THE CITY OF WALTHAM  
MASSACHUSETTS

**Capacity, Management, Operation & Maintenance (CMOM)  
Program Assessment and Corrective Action Plan Consultant**

**ADDENDUM NO. 2**

December 4th, 2019

**SEWER SYSTEM MAP  
CITY OF WALTHAM**

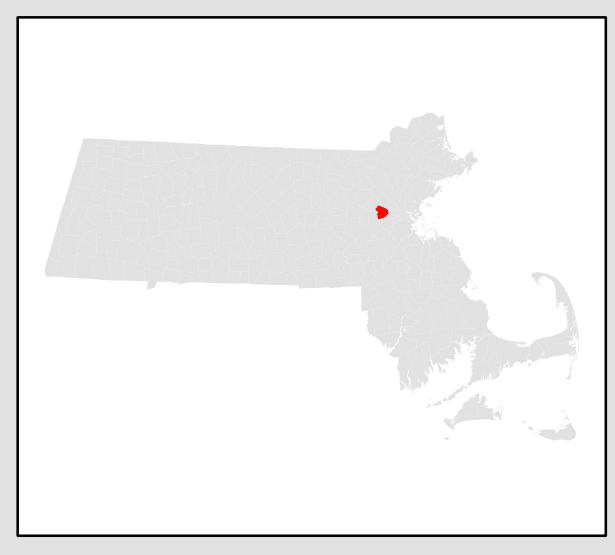
**Q9.** Please provide a map of the existing sewer system.

**A9.** See the attached map generated from GIS.
